PRATT & WHITNEY CANADA
SERVICE BULLETIN

P&WC S.B. No. 41074

TURBOSHAFT ENGINE
FUEL-COOLED OIL COOLER - INSPECTION OF

FUEL COOLED OIL COOLER - HEAT EXCHANGER WELDMENT INSPECTION

FIGURE 3
This figure is showing the top cover welded joint. The blue line indicates the area to be inspected around the circumference of the welded area.

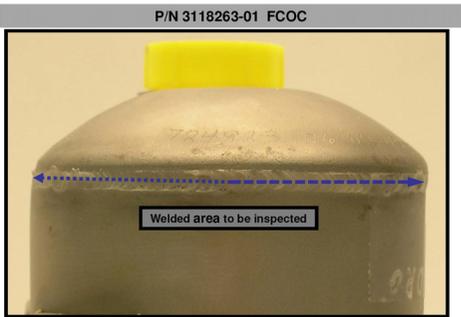
A one time factory inspection of Fuel Cooled Oil Coolers (FCOC), Meggitt part number: 10841B and 10845B to validate conformity of the welded area around the shell and T/A collector. This inspection is a preventative measure to ensure no stress conditions exist that could result in fatigue cracking.

Meggitt (Troy), Inc. will perform an inspection of the FCOC turnaround collector weld and perform rework of this weld if a non-conformance is identified per repair specification PS 899. A rotatable exchange service pool will be utilized when
